ADDENDUM NUMBER ONE

DATE: March 28, 2019

PROJECT: City of Myrtle
Renovations to 13th Ave. South for Facilities Maintenance

METAL STUD-TO-SLAB CONNECTION
(8" METAL STUD WALL)
NO SCALE

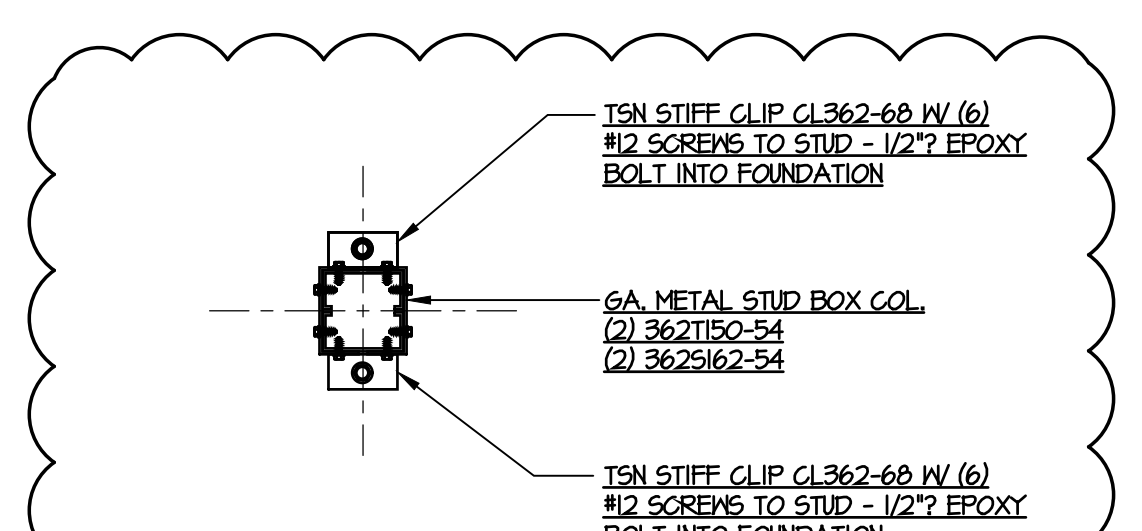
Refer to modification of the porch framing from wood to metal studs and metal decking.
